## Department of Environmental Quality

Re: WQ: Variance Approval: 248-25-000015-VAR: 16924 Upland Rd; T.20S; R.10E; Sec. 13C; Tax Lot 7800; 0.51 Acres; Deschutes County.

### **Variance Decision:**

**Schedule A – Annes Butte LLC**  
**Variance Report - Special Conditions**  
**T 20S, R 10E, Sec: 13C, TL 7800**

Figure 2. Site Plan

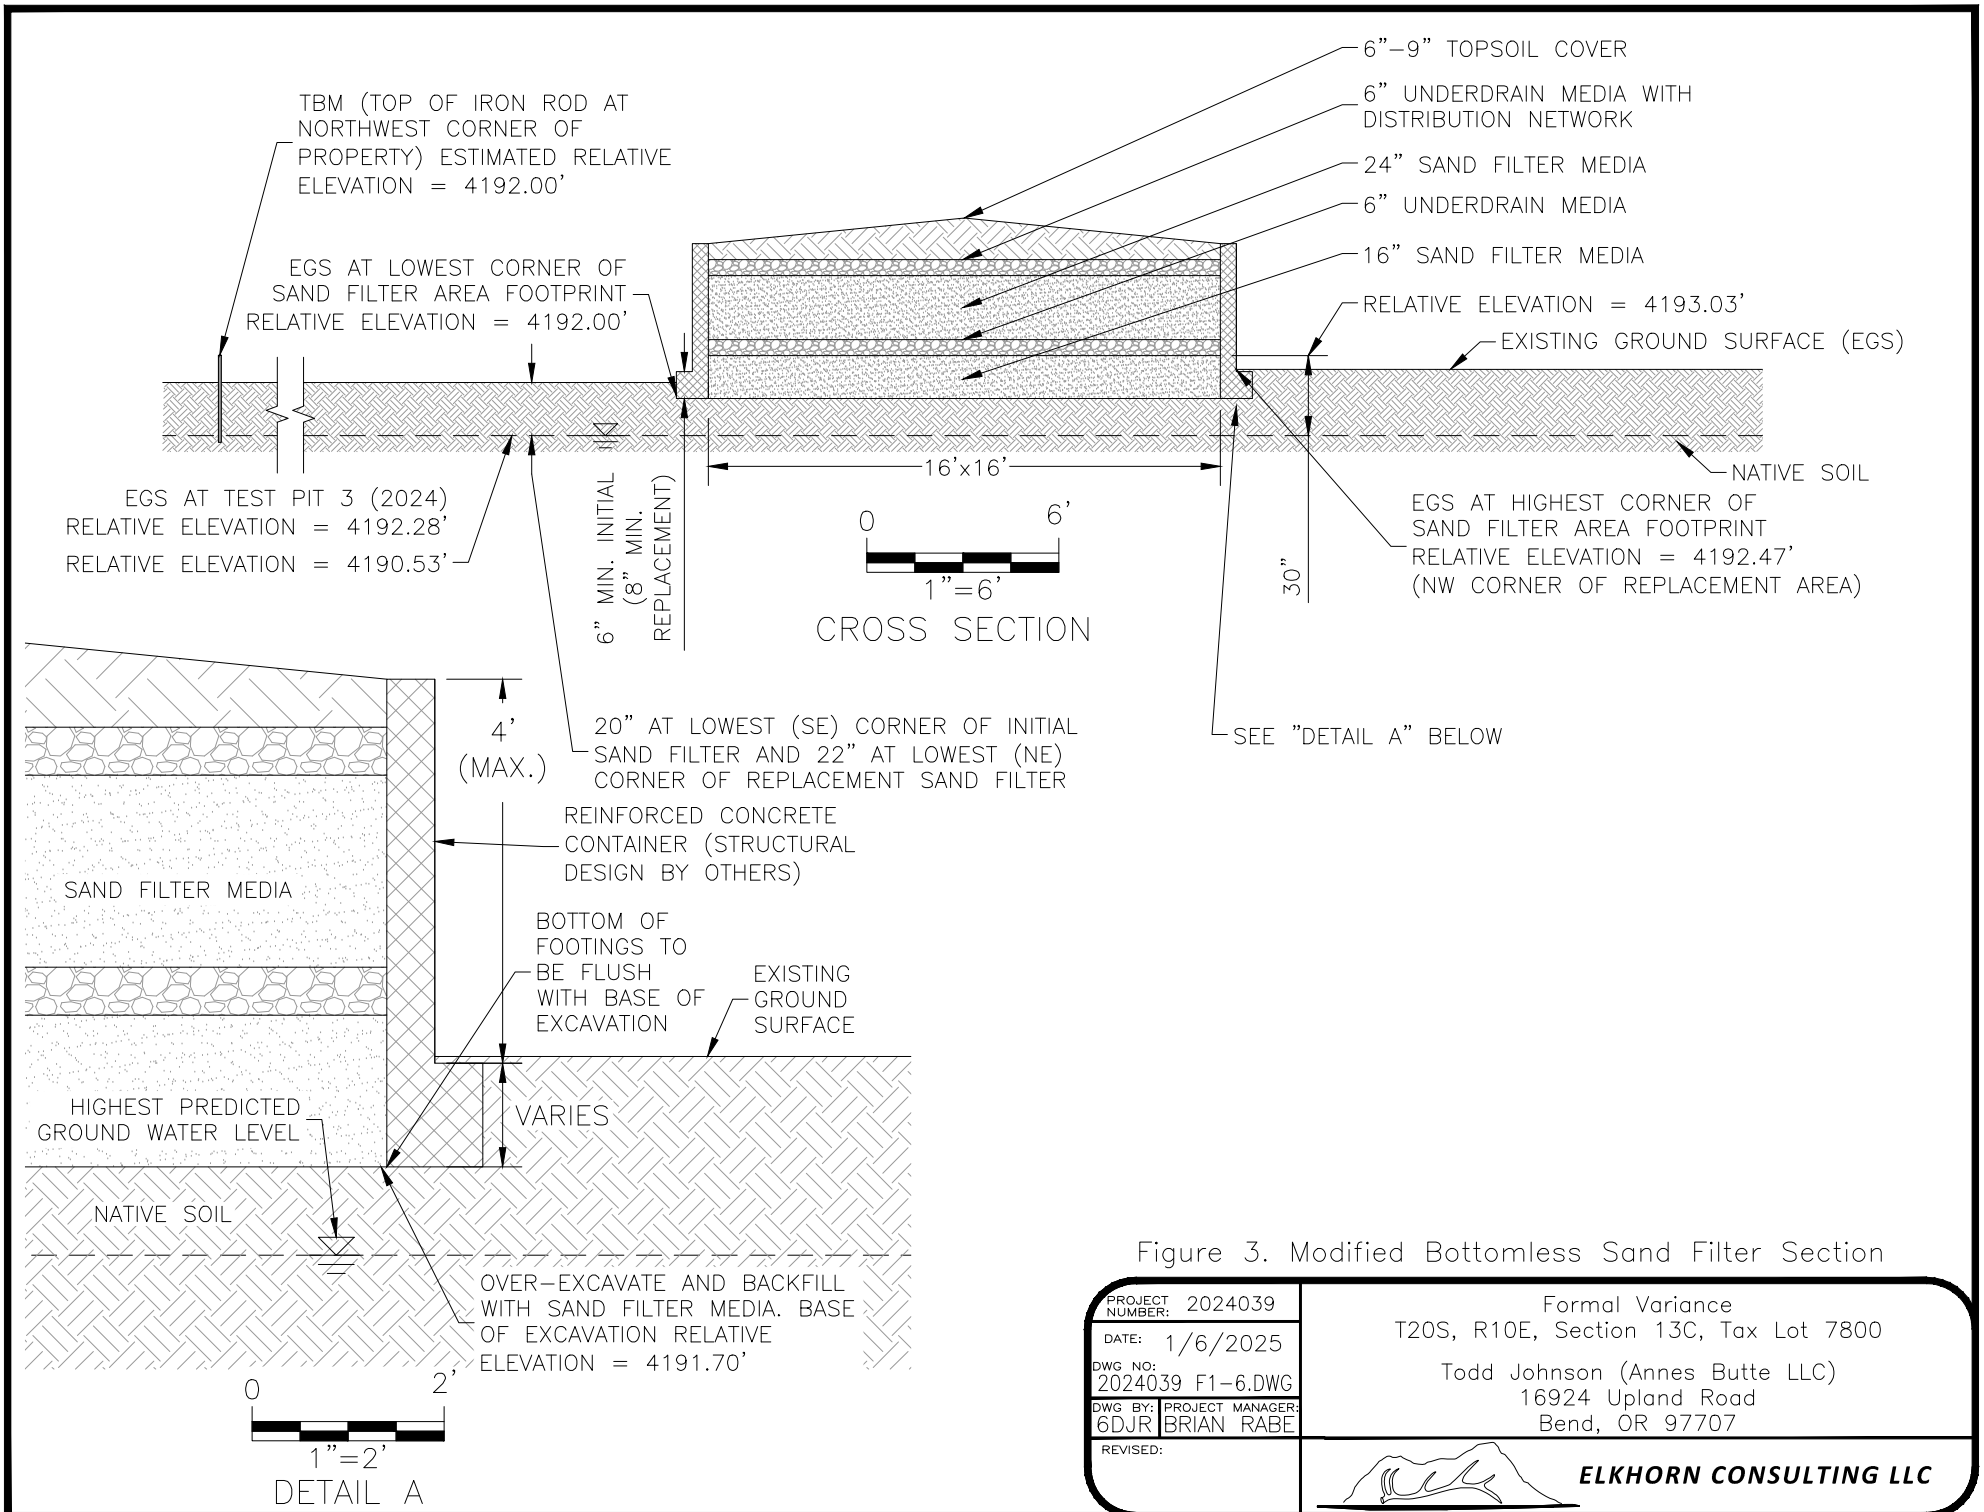
Based on review and evaluation of the variance record and observations made during the variance hearing, I am pleased to inform you that the variance from the rules cited above is hereby granted. In my opinion, it would be unreasonable to prohibit this method of wastewater treatment by strictly following the administrative rules at this specific location at this time. It is my judgement that the proposed system is not likely to present a public health hazard risk or have any significant adverse impacts to groundwater or surface water quality if properly operated and maintained.

- The proposed Orenco® AdvanTex AX20N-Mode 3B system is currently approved as a system meeting DEQ's Treatment Standard 2; OAR 340-071-0100(168) "Treatment Standard 2".

- Treatment Standard 2, for the reduction of fecal coliform, will be met or exceeded with pre-treated effluent from the AX20N-Mode 3B unit (proposed w/o UV disinfection) and the RidNOx™ unit that will discharge into a 250 square foot bottomless sand filter with an additional 6-inches (8-inches for replacement) of sand filter media (embedded 6-inches below ground surface) placed below the filter to meet or exceed the minimum 24-inch separation requirement to groundwater below. Note: The bottomless sand filter is assumed to

Special Conditions and requirements for the Orenco® AX20N-Mode 3B Alternative Treatment Technology unit with a RidNOx™ system followed by an elevated 250 square foot Bottomless Sand Filter at 16924 Upland; T.20S; R.10E; Sec. 13C; Tax Lot 7800; 0.51 Acres; Deschutes County.

6. The setback to all wells from the initial or replacement bottomless sand filters is to be at least 100 feet.
7. The County shall inspect the installation of this system at those stages of construction they identify as appropriate to ensure proper construction.

Figure 3. Modified Bottomless Sand Filter Section

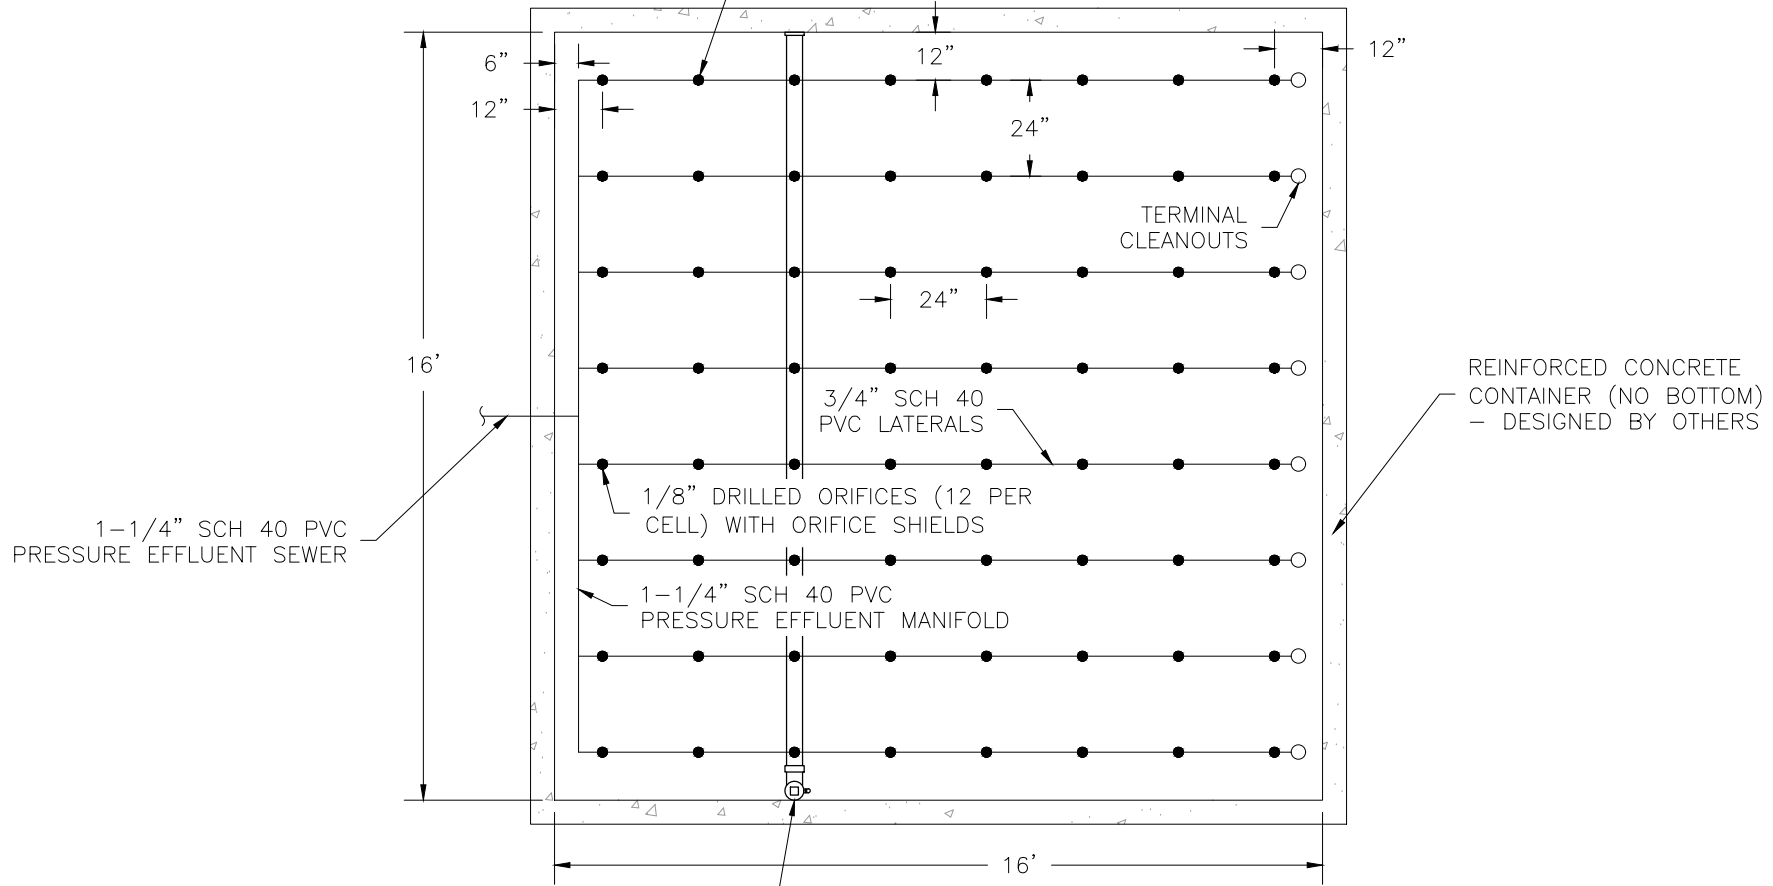
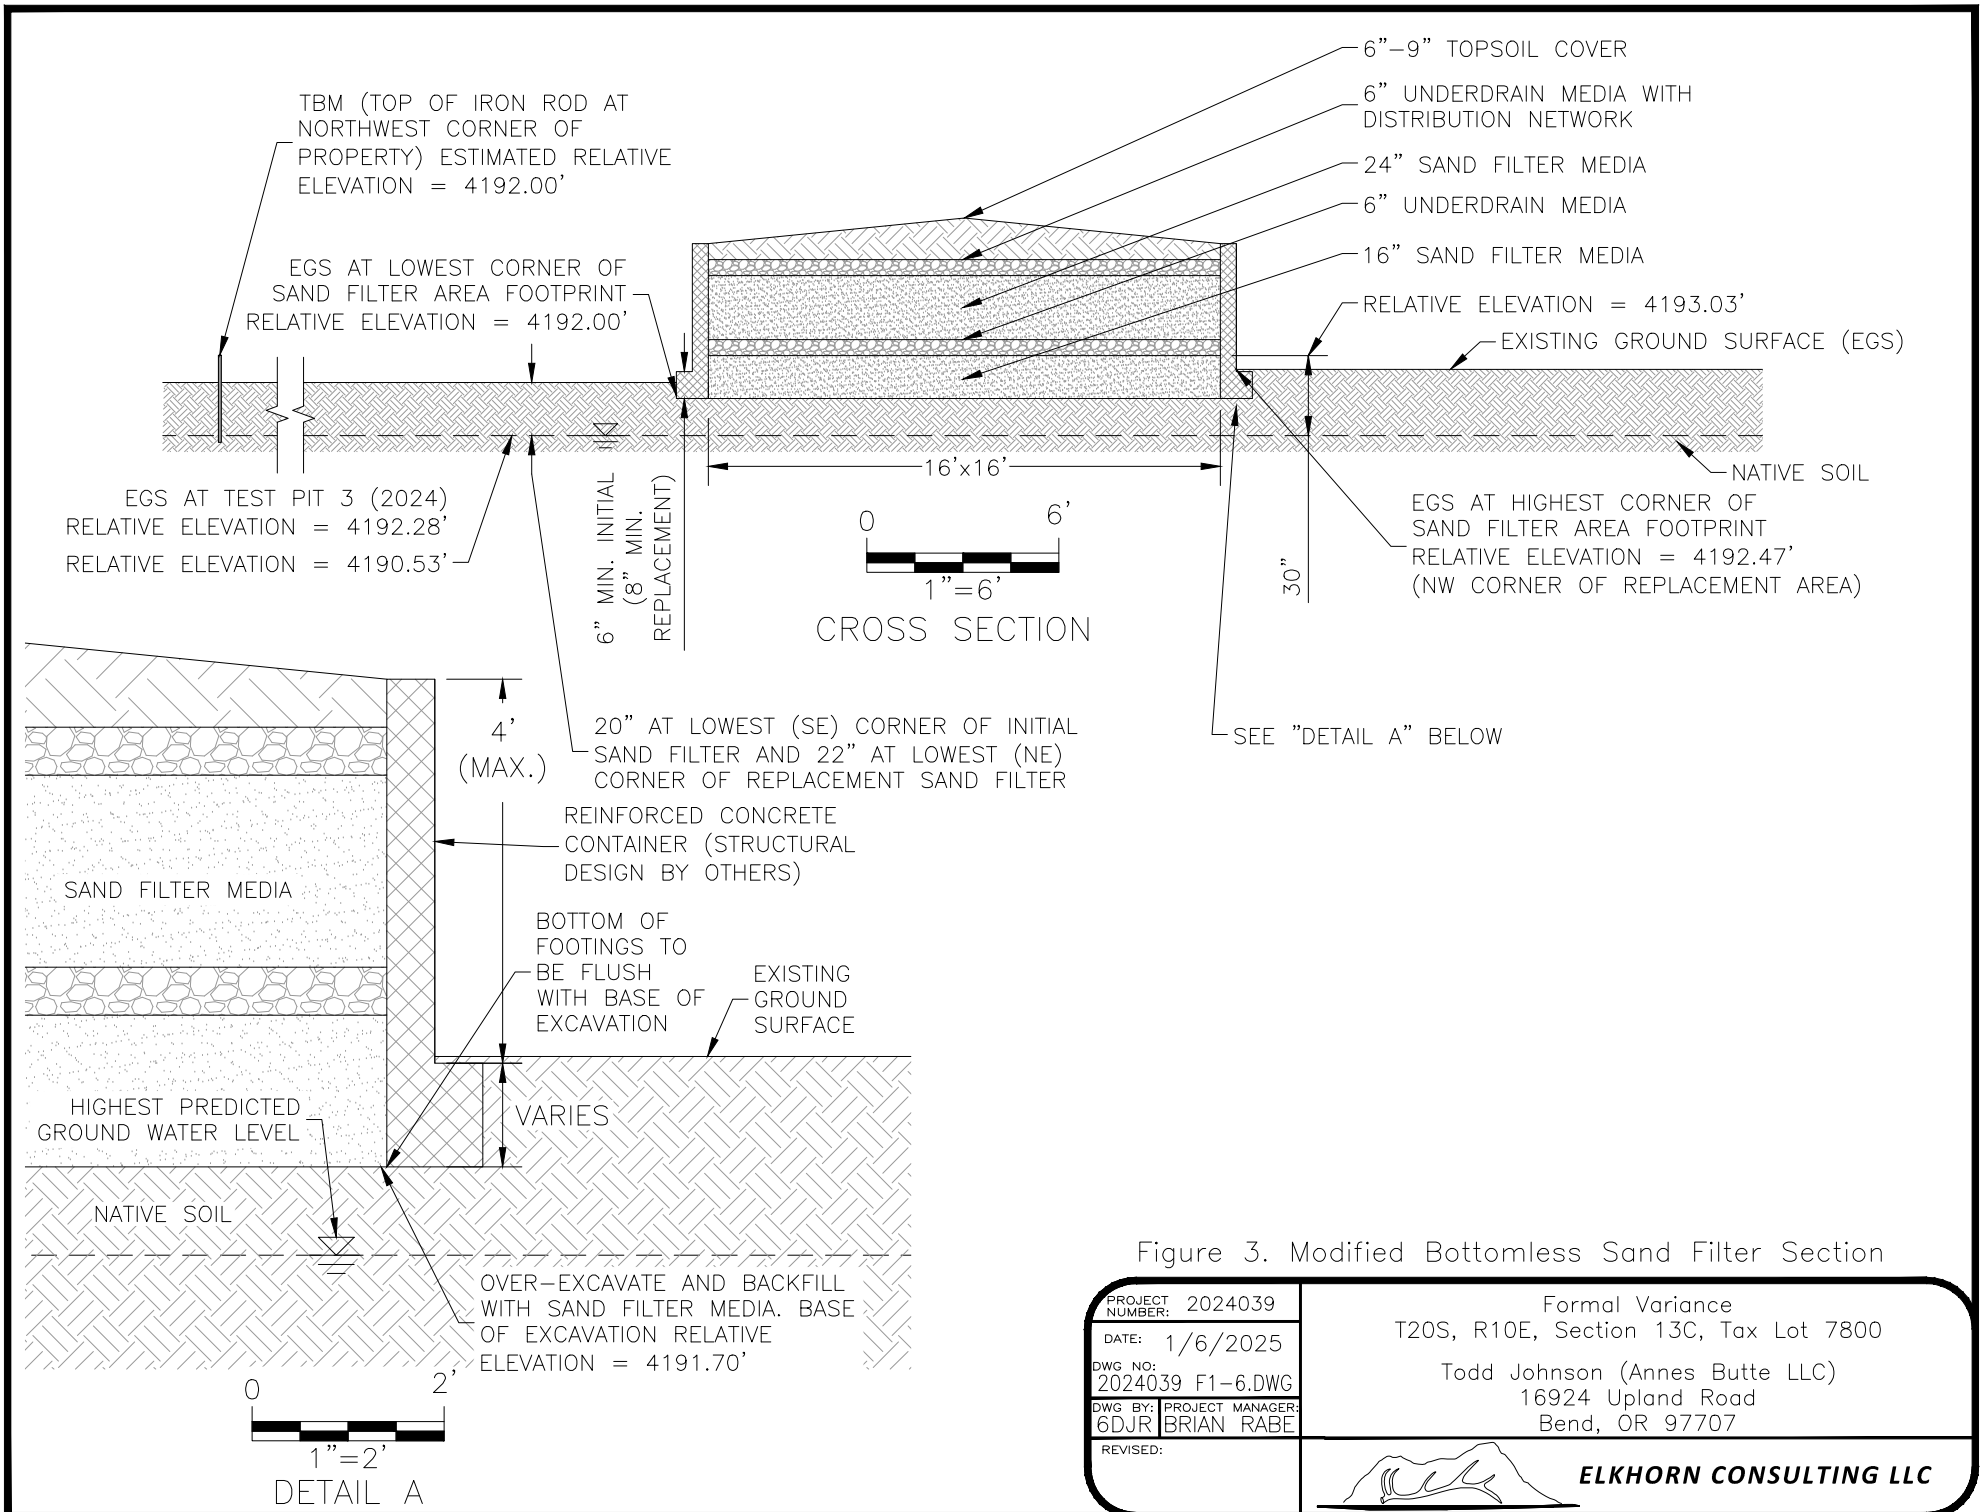
The effluent from the ATT and RidNOx™ system, discharging through a bottomless sand filter, will have a significant reduction in BOD, TSS, TN, and Fecal Coliform. In this proposal, treated ATT to RidNOx™ effluent will be discharged into a 250 square foot bottomless sand filter with an additional 7- inches (9 inches for replacement) of sand filter media embedded 6 - inches into the native soil that will be used to exceed the 24-inch separation from the shallowest water table depth standard by providing a total separation of 30 - inches. The additional media will mitigate the lack of vertical separation from the bottom of the sand filter to the highest level of groundwater on site. The RidNOx™ unit is expected to provide a significant reduction of Total Nitrogen (and Nitrate) before the treated effluent enters the bottomless sand filter with a basal area intersecting the native soil and ultimately the groundwater below.

The proposal to overcome the site limitations is by installing an Orenco® AdvanTex AX20N-Mode 3B Alternative Treatment Technology System followed by a RidNOx™ solid-phase carbon flow-through filter before discharging to a 250 sq. ft. elevated Bottomless Sand Filter system constructed on a 12-inch bed of sand filter media embedded 6 inches into the native soil. It is expected that the highest level of groundwater within the lowest point of the sand filter areas will come to 21- inches bgs. The proposal overcomes this limitation by providing additional sand filter media with 7- inches (9 – inches for replacement) of extra vertical separation and providing a total 30-inch separation to the shallowest predicted groundwater depth. The rest of the sand filter will be “conventional” from there up, consisting of 6 inches of underdrain media, 24- inches of sand filter media, 6- inches of drain media (with the distribution laterals), filter fabric, and 6-9 inches deep of final backfill on top. The sand filter will be contained within a supporting berm with a slope no steeper than 3:1.
